AIR RESOURCES BOARD

Executive Order G-70-25-D

Relating to the Modification of the Certification of the
Atlantic Richfield Balance
Phase II Vapor Recovery System

ARCO Phase II Balance Vapor Recovery System
Alternate Hose Configuration

Exhibit 3

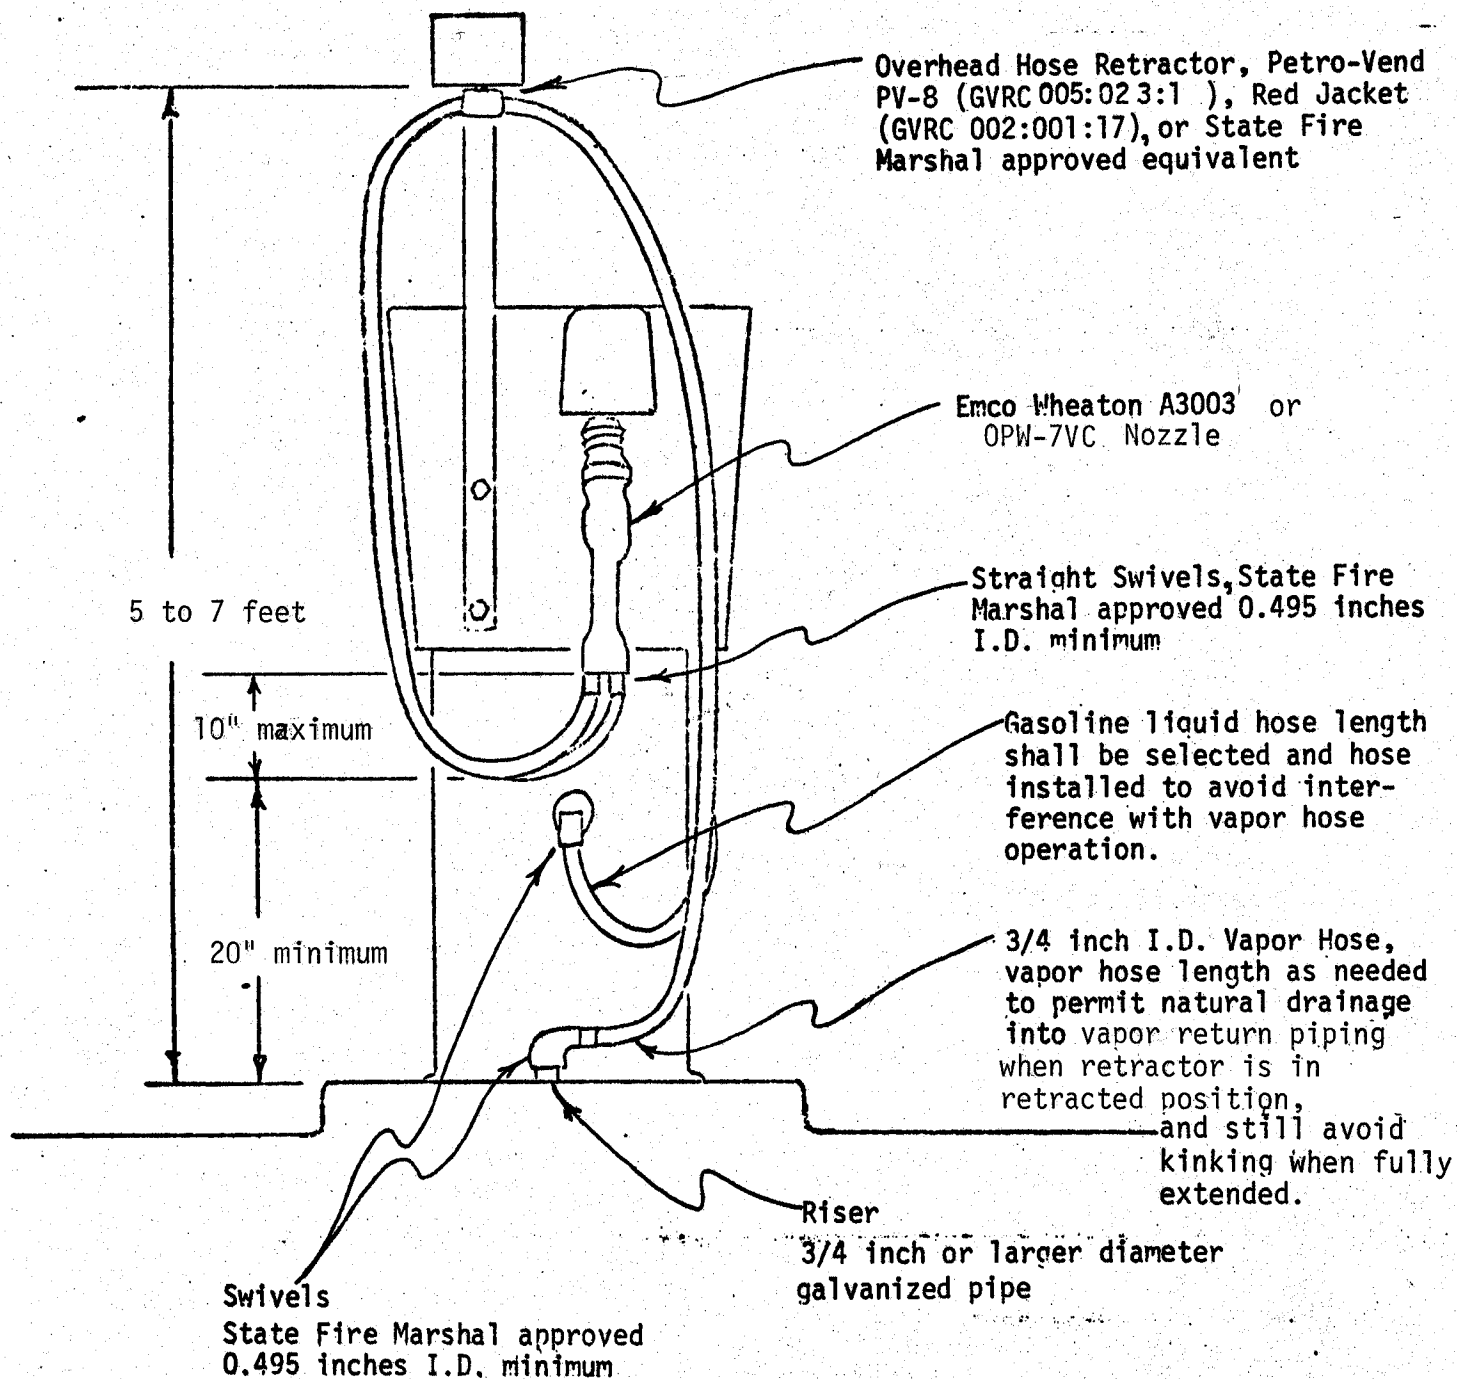
IT IS ORDERED AND RESOLVED: That the certification Executive Order G-70-25-C issued on January 22, 1980 for the Atlantic Richfield balance Phase II vapor collection and disposal system is hereby modified to include an alternate hose configuration, described in Exhibit 3. The system hereby modified is certified to be at least 95% effective in self-serve and/or attendant use at gasoline service stations in conjunction with Phase I vapor recovery systems which have been certified by the Air Resources Board. The system is described in Exhibits 1, 2, and 3 attached hereto.

- Notes:
1. Flow limiter Emco Wheaton A-10 (GVRC 001:007:1) required with Emco Wheaton nozzle.
 2. Recirculation trap not required.
 3. Use 6 to 8 hose ties, with first tie approximately 24 inches from nozzle.
 4. Vapor return piping may be installed inside dispenser and through the dispenser cabinet.

5. Each vapor hose shall be located such that the center line of the hose fitting, at the recirculation trap (if externally mounted) or at the dispenser cabinet swivel mounting (if trap is internally mounted), is not more than 3-1/2 inches above the top surface of the island and is as close as possible to the top surface of the island. *(Does not apply to alternate hose configuration, Exhibit 3.)*

6. For dispenser islands greater than 5 feet in width, each vapor hose length shall not be longer than the sum of one-half the dispenser island width, in feet, plus 6 feet. *(Does not apply to alternate hose configuration, Exhibit 3.)*

7. State Fire Marshal approved swivels for this system shall be selected and installed on hoses to prevent hose kinking.
8. Product hoses one foot or more longer than the vapor hose shall be installed at each dispenser to provide for full extension of the vapor return hose. *(Does not apply to alternate hose configuration, Exhibit 3.)*
